From: "Oscar Paulson" <paulson@tribcsp.com>
To: "Stephen Cohen" <SJC7@nrc.gov>
Date: 07/13/2006 3:10 PM
Subject: Re: Excavation Sampling
CC: "Betty Garrett" <BSG@nrc.gov>

From: Stephen Cohen
To: Oscar Paulson
Cc: Betty Garrett
Sent: Thursday, July 13, 2006 8:14 AM
Subject: Re: Excavation Sampling

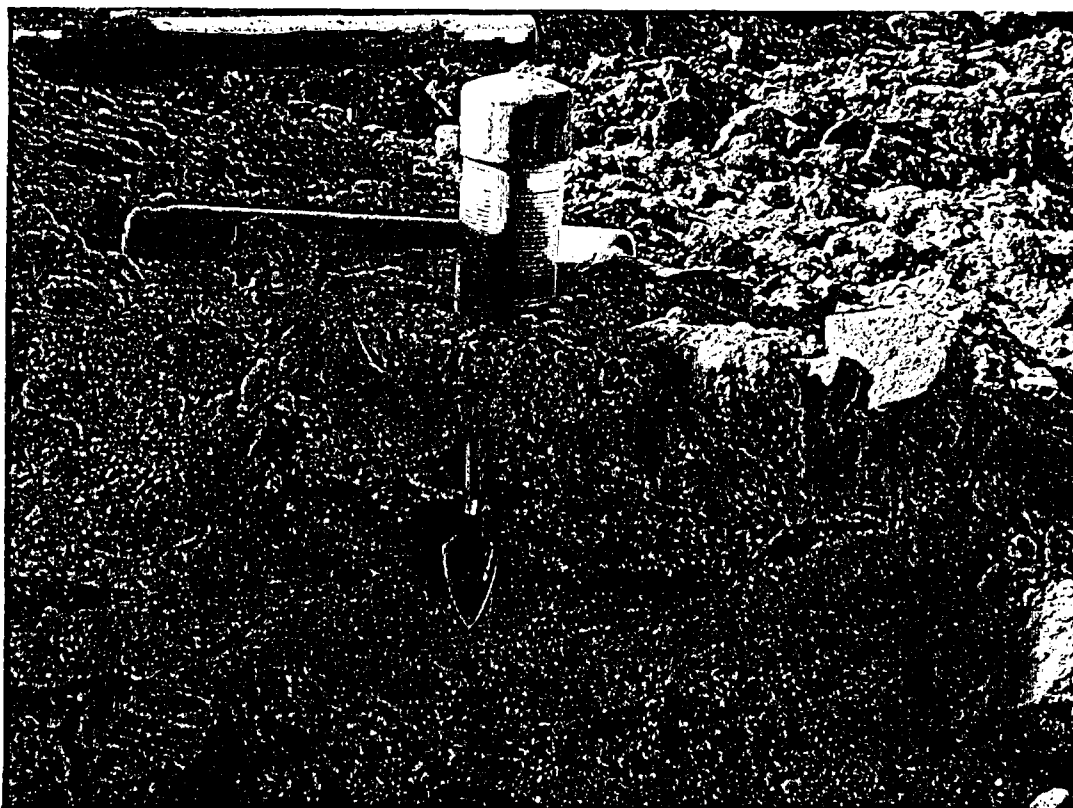
The excavation has attained what appears to be clean bottom in the vicinity of TMW-90 and North of the well to the highwall beneath the Southeast corner of the Mill Building. The image below shows the remaining slotted pipe from TMW-90 and the clean green clay underlying the contaminated sands.

I wanted to confirm with you the sampling protocol and that a single composite sample from each grid collected from 0 to 15 centimeters beneath the excavation bottom is sufficient. I am asking because in your e-mail of Monday, July 10, 2006 stated:

I wanted to be absolutely sure that additional composited samples from greater depths say 15 centimeters to 30 centimeters did not have to be collected from each grid as well in addition to any other types of composited samples. A trackhoe will be used to assist with sampling since the excavation is quite hard (rock). We have only one chance to get this sampling right because assuming that the sample results are satisfactory, backfilling of the area will commence upon receipt of sample data showing the area to be clean since we want to get backfill placed against the highwall beneath the Mill Building as soon as possible so that caving beneath the foundation does not occur. The image below shows the highwall beneath the foundation and it is obvious why that area of the pit should be backfilled as soon as possible.

The leftmost well casing in the above image is TMW-90. Initial gridding and sampling would be performed between that well and the Mill Building with backfilling of that area to follow upon receipt of satisfactory sample results.

This e-mail confirms our understanding that one composite from 0 to 15 cm from each grid is acceptable.
